METROPOLITAN GOVERNMENT OF NASHVILLE AND DAVIDSON COUNTY

STAFF RECOMMENDATION 1107 Boscobel Street November 16, 2016

Application: New construction—infill and outbuilding; Setback determination
District: Lockeland Springs-East End Neighborhood Conservation Zoning Overlay
Council District: 06
Map and Parcel Number: 08313017100
Applicant: Jason Gibson, Smith Gee Architects
Project Lead: Melissa Baldock, melissa.baldock@nashville.gov

1
SITE PLAN
 1/16" = 1'-0"

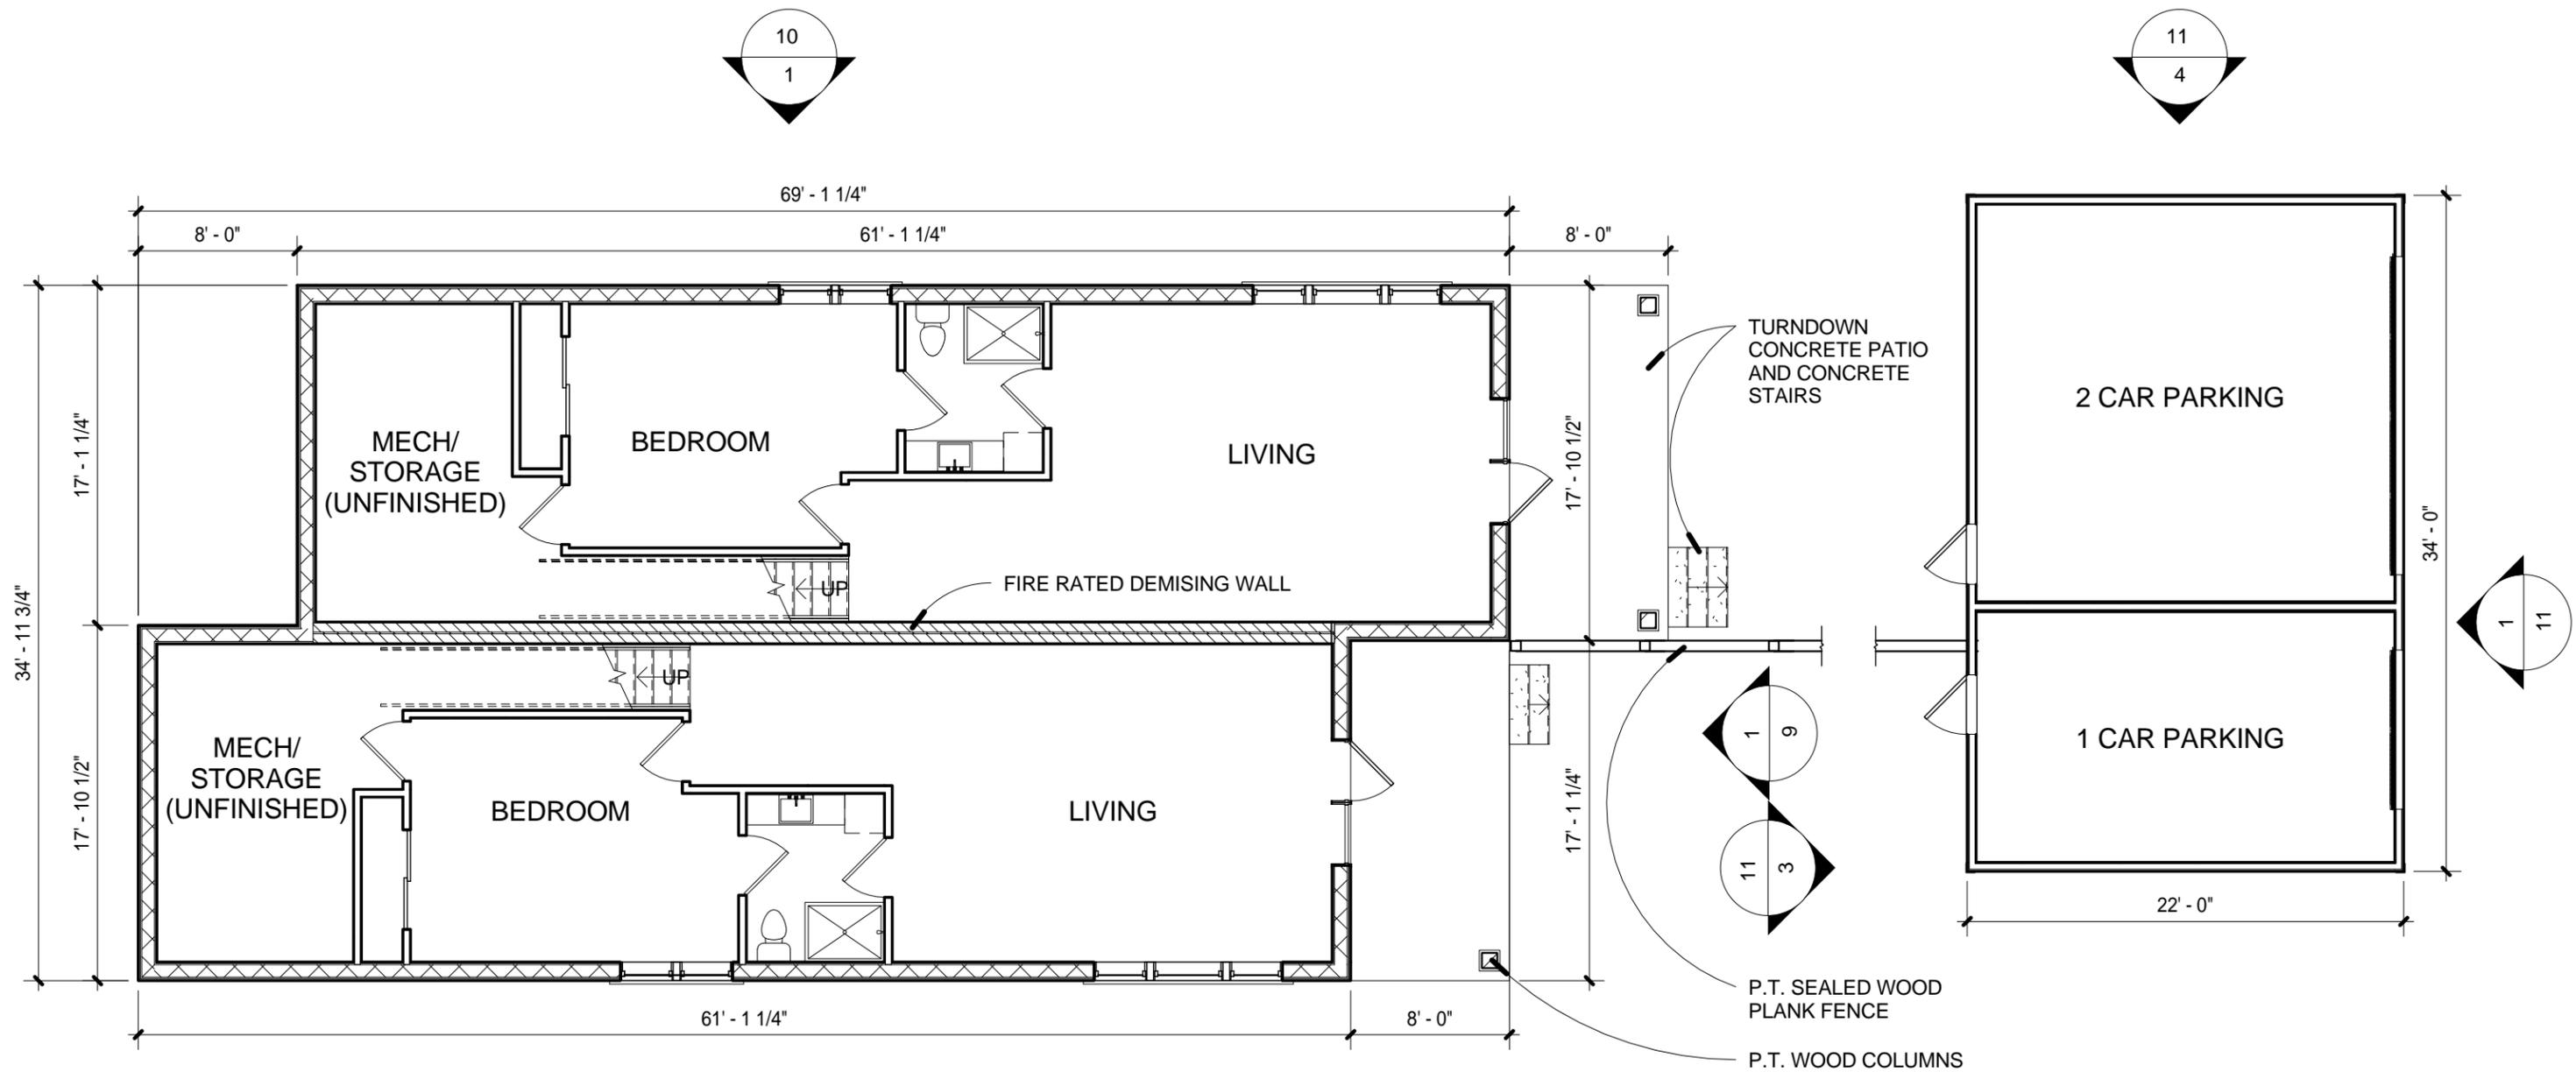
Setback & Rhythm of Spacing: The proposed infill meets all base zoning setbacks. It will be approximately six feet (6') from the side property lines and over sixty feet (60') from the rear property line. The front setback will approximate the side setbacks of the two infill houses on either side. Staff finds that the proposed setback and rhythm of spacing meet Section II.B.3. of the design guidelines.

MINIMUM	PROPOSED
Space between principal building and DADU/Garage	20'	31'
Rear setback	20'	10'
L side setback**	5'	3'
R side setback**	5'	12'
How is the building accessed?	From the alley or existing curb cut	Alley

The new outbuilding does require a rear setback determination. When an outbuilding has a footprint greater than seven hundred square feet (700 sq. ft.), base zoning requires that the structure be located twenty feet (20') from the rear property line and five feet (5') from the side property lines. In this instance, the proposed outbuilding does not meet the rear or the left/west side setbacks. It is proposed to be located three feet (3') from the left/west side property line and ten feet (10') from the rear property line. Staff finds that the proposed setbacks are appropriate for several reasons. Historically, outbuildings were located at the rear of the property, close to the rear and side property lines. In addition, when a structure has a footprint of less than 700 sq. ft., the base zoning setbacks are three (3') from the side and ten feet (10') from the rear, like what is proposed. Also, the ten foot (10') rear setback will allow for more space in between the historic house and the outbuilding. Staff recommends approval of the setback determination. The project meets Section II.B.8. of the design guidelines.

SOUTH ELEVATION - BOSCOBEL ST.

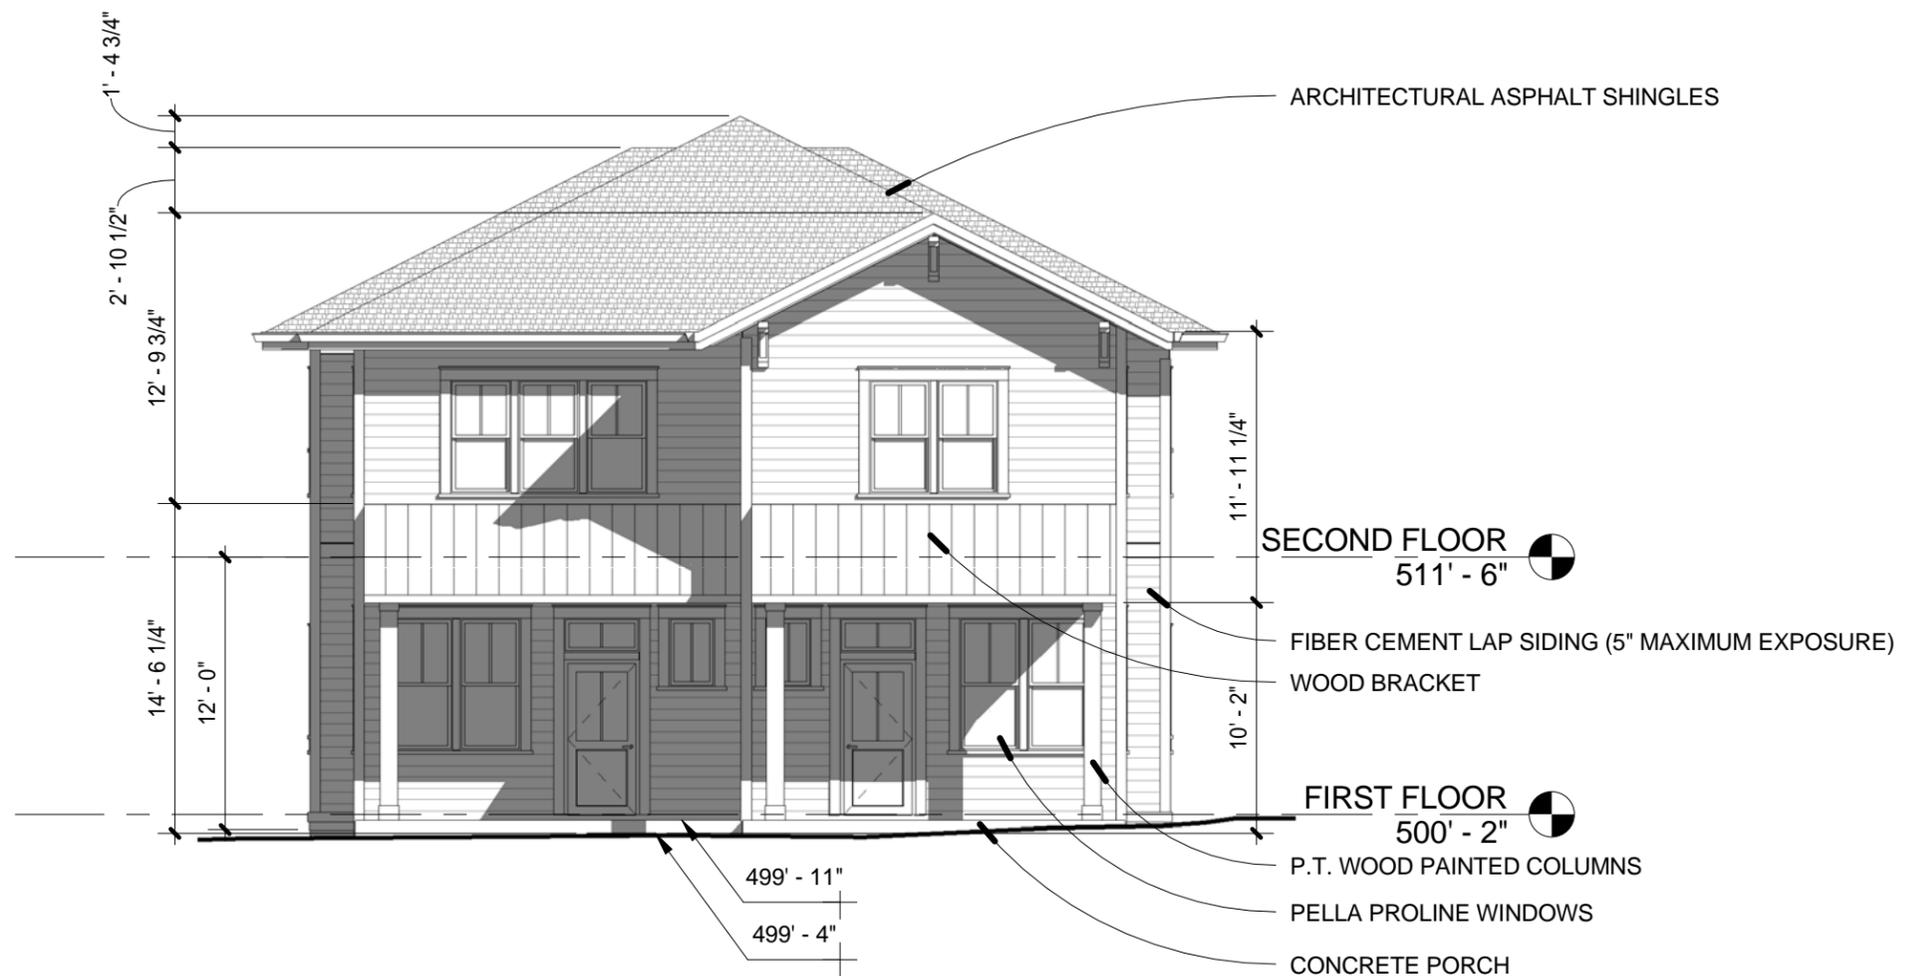
Height & Scale: The proposed new duplex will be two stories tall, with a maximum height of thirty-one feet, six inches (31'6") from grade and an eave height of twenty-two feet (22') from grade. On either side of the lot at 1107 Boscobel, there are two-story infills that were approved by MHZC. Both 1105 and 1109 Boscobel were approved to be two stories and approximately thirty feet, six inches (30'6") from grade, with eave heights of approximately twenty-one feet (21'). Staff recommends that the overall ridge and eave heights be reduced to be no more than thirty feet, six inches (30'6") and twenty-one feet (21'), respectively. This will ensure that the house is more in keeping with the historic context, where one and one-and-a-half story houses are predominant, although there are some two-story houses. The heights of historic houses in the immediate vicinity range from eighteen feet to thirty-one feet (18'-31').

With the condition that the overall eave and ridge height be reduced by one foot (1'), Staff finds that the infill's height and scale meet Sections II.B. 1 and 2 of the design guidelines.

1. The ridge height be reduced to be no taller than thirty feet, six inches (30'6") and the eave height be reduced to be no taller than twenty-one feet (21');
2. The finished floor height shall be consistent with the finished floor heights of the adjacent historic houses, to be verified by MHZC staff in the field;
3. Staff approve the final details, dimensions and materials of windows and doors prior to purchase and installation;
